## ADDENDUM #01

ACES at CHASE

STATE PROJECT NO. 244-0044 MAG

6. **ALL Bidders** should review and incorporate the **attached Bulletin #1 dated December 16, 2025** prepared by **S/P+A** and their consultants. This Addendum includes:

5 EXPANSION/SEISMIC JOINT FITTING DETAIL  
SCALE: NONE

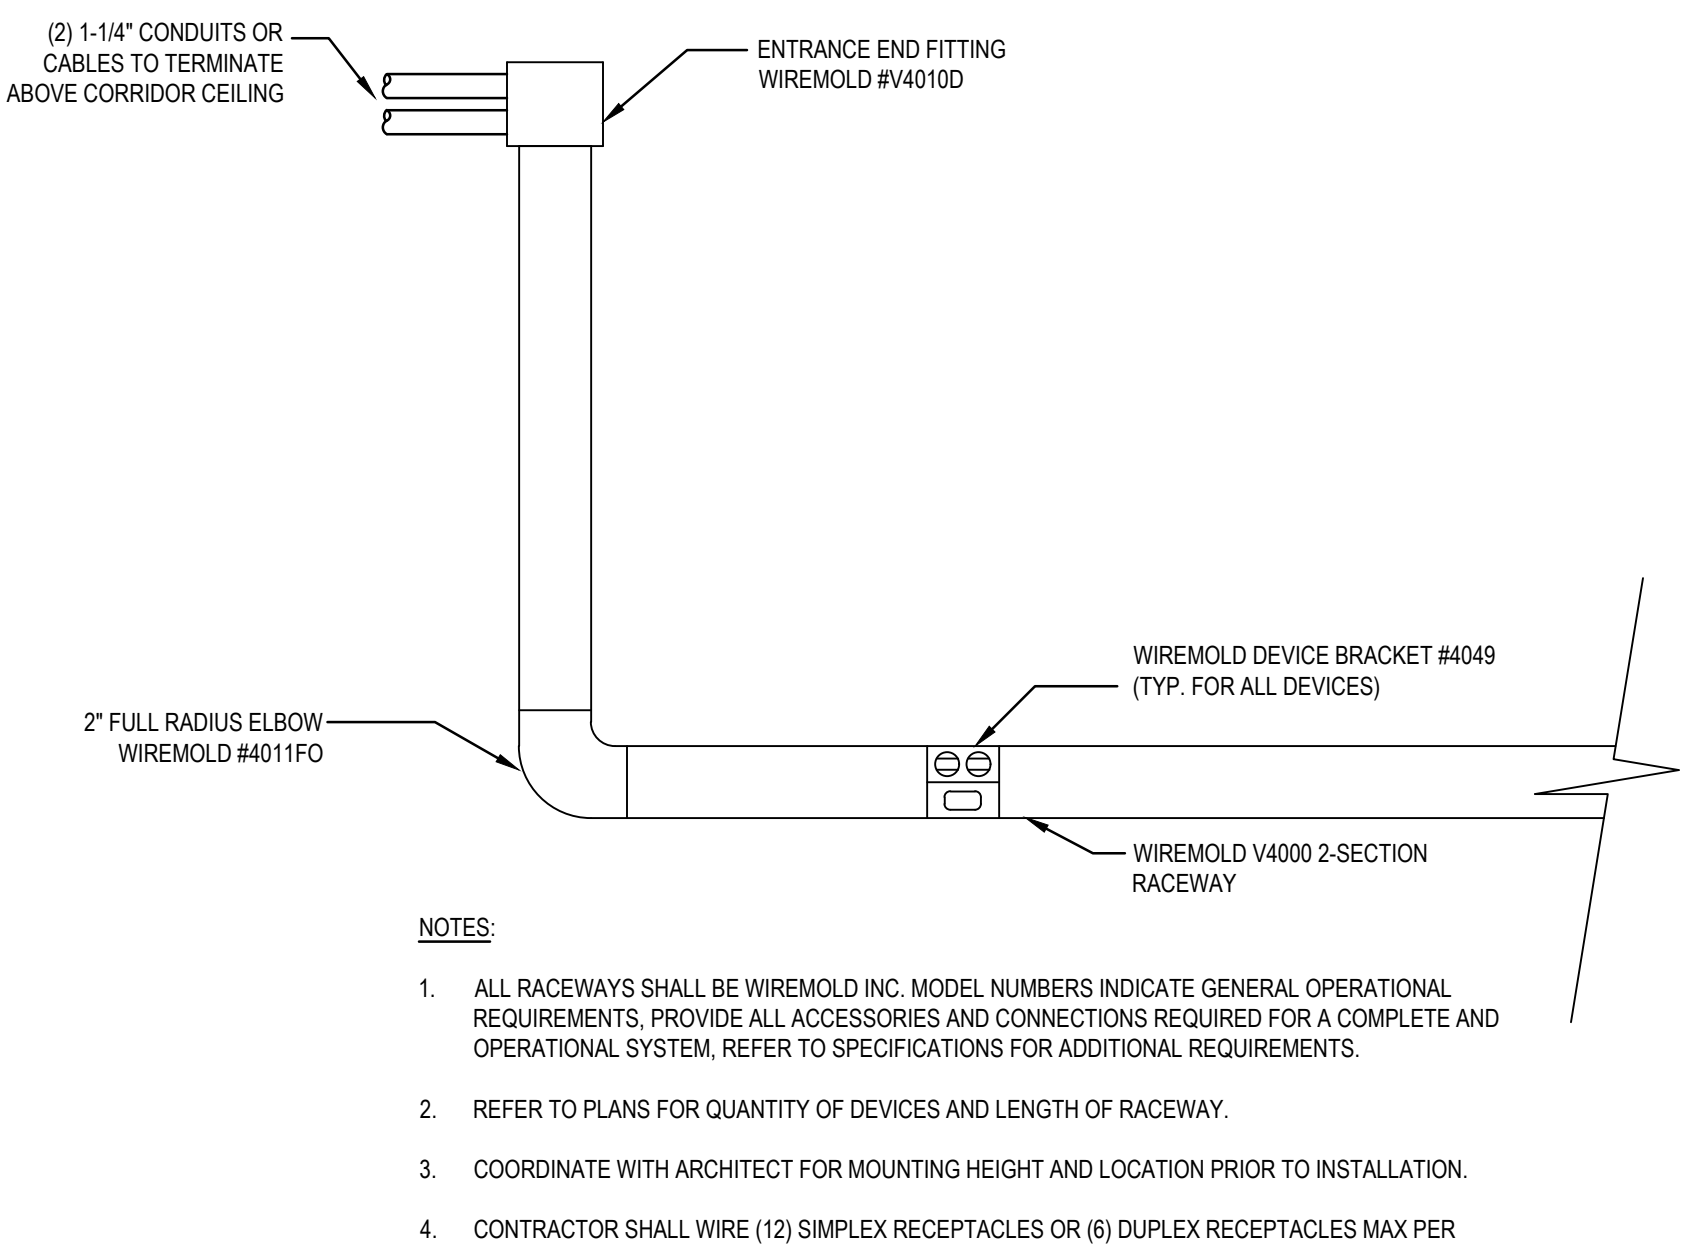
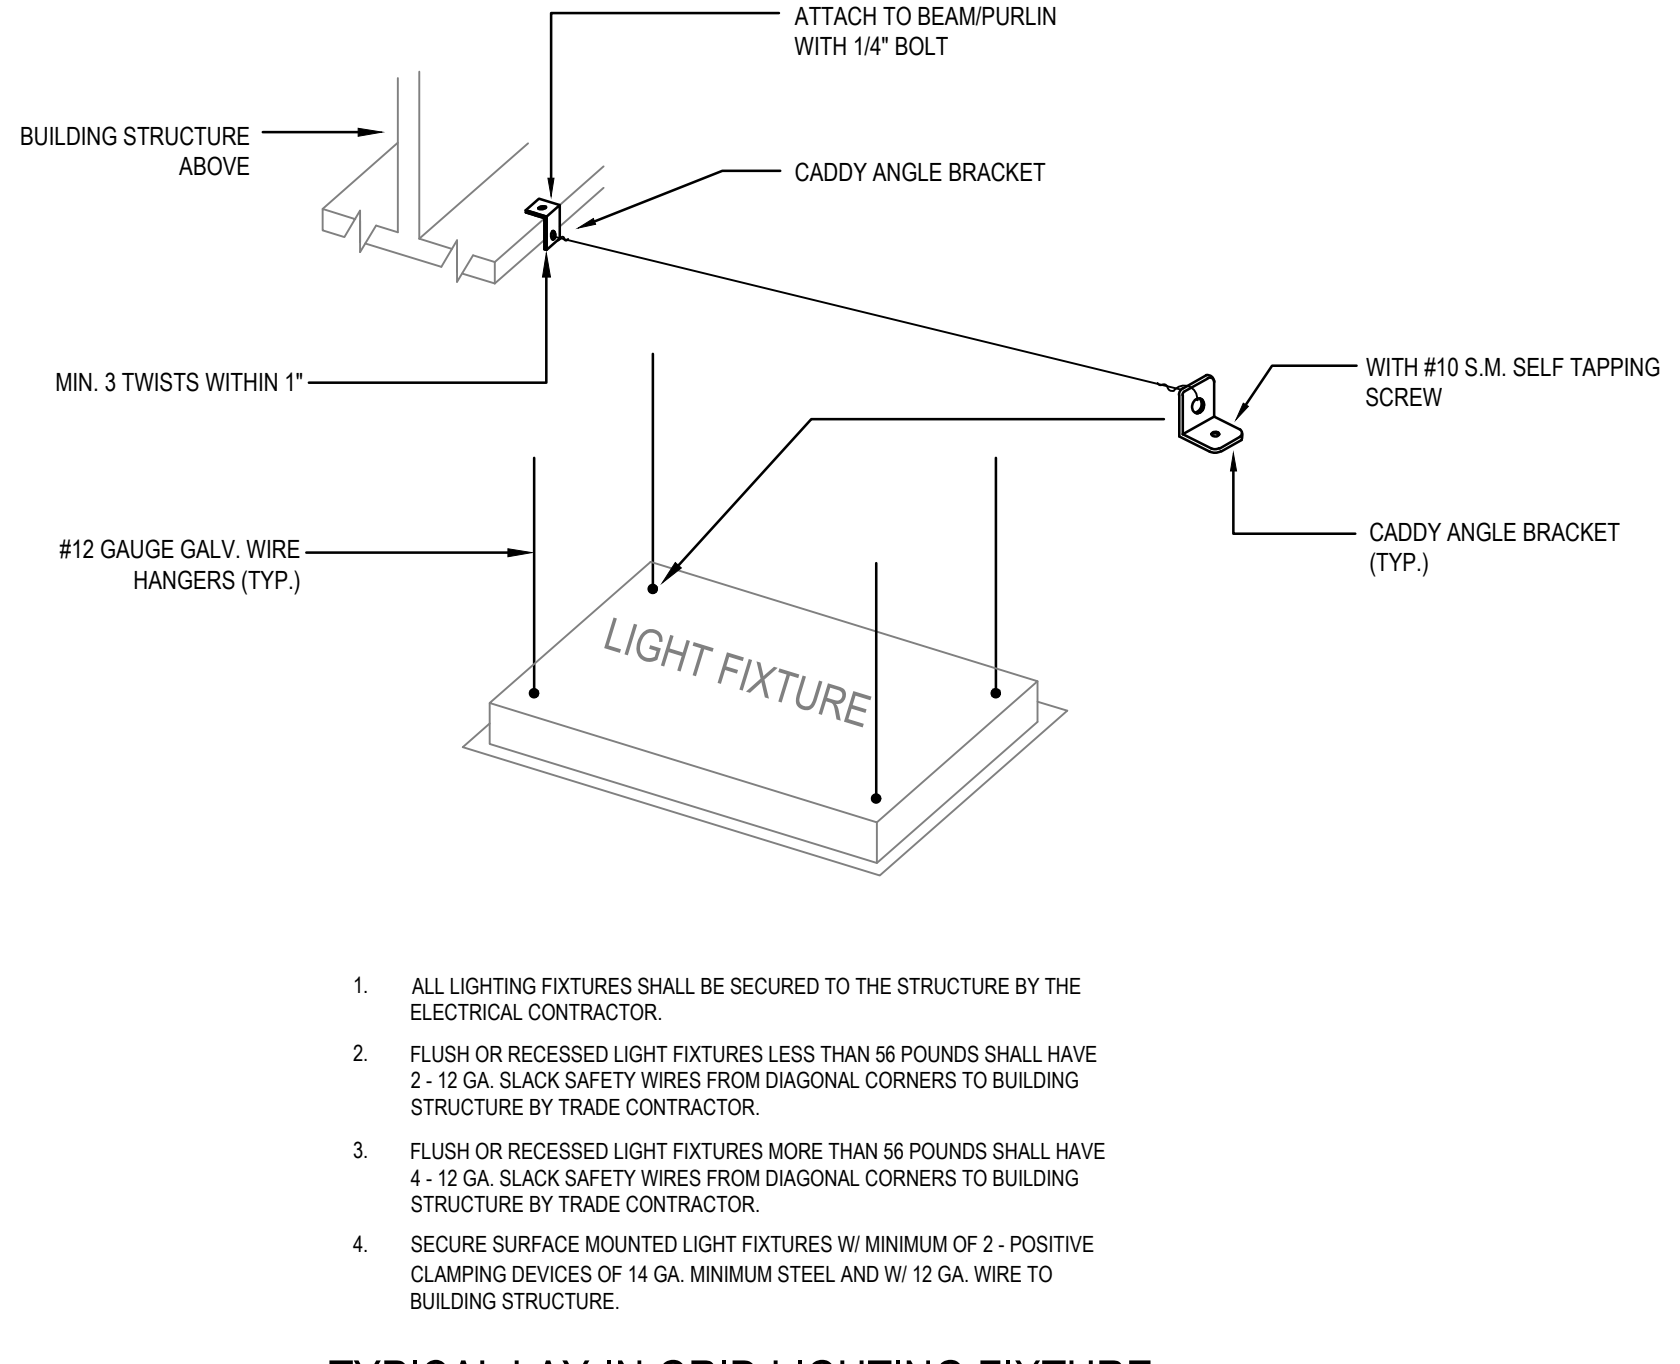
- Building 5, DRAWING E400-5, BUILDING 5 – DETAILS, delete in its entirety. A new DRAWING E400-5 has been added and is attached as part of this bulletin.\* *(Per Cx)*
